Title: Type2AB_EVB		
Size: A	Document Number: JS-1055	Rev: V2.0
Date: Wednesday, October 30, 2024	Sheet 1 of 3

Type2AB Module

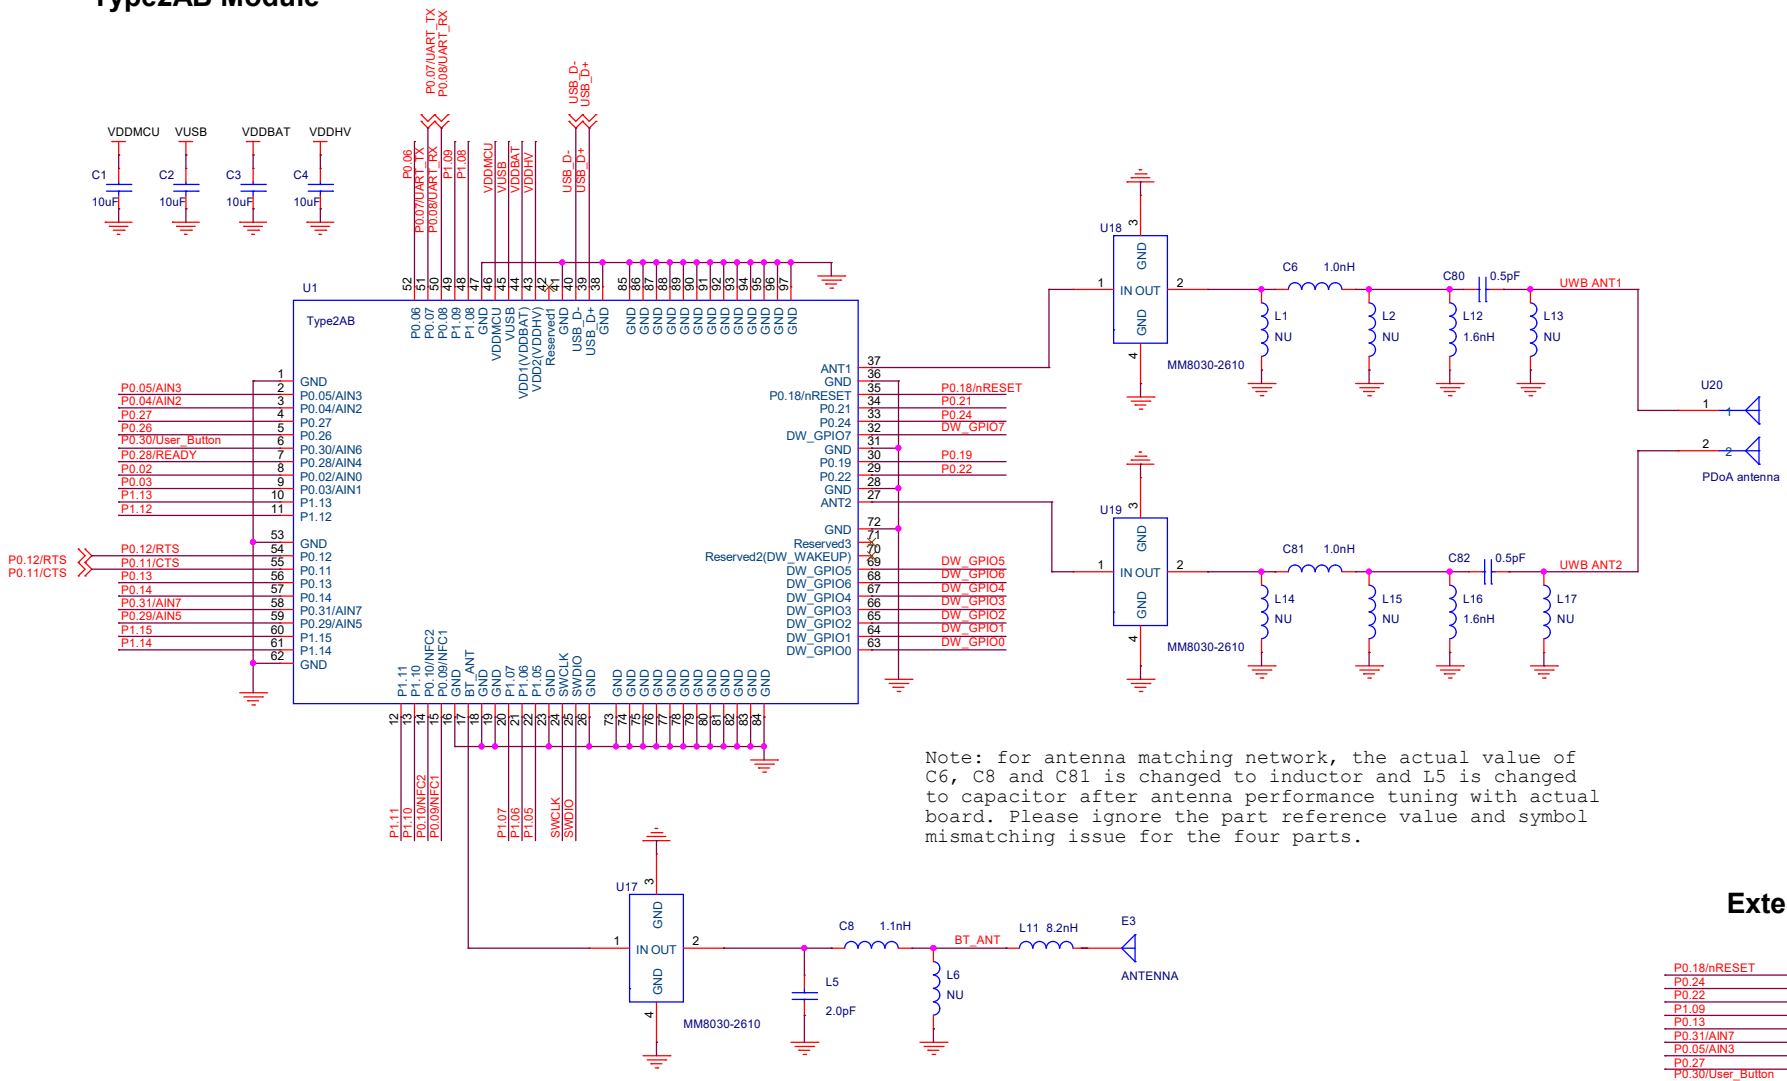
Revision	Date	Update
V0.1	2022/6/23	Initial release
V1.0	2022/8/3	Update UWB and BLE antenna matching network value.
V1.1	2024/9/14	Add one note about antenna matching network.
V2.0	2024/10/30	Modify symbol of antenna matching circuit to accord with material.

Note: for antenna matching network, the actual value of C6, C8 and C81 is changed to inductor and L5 is changed to capacitor after antenna performance tuning with actual board. Please ignore the part reference value and symbol mismatching issue for the four parts.
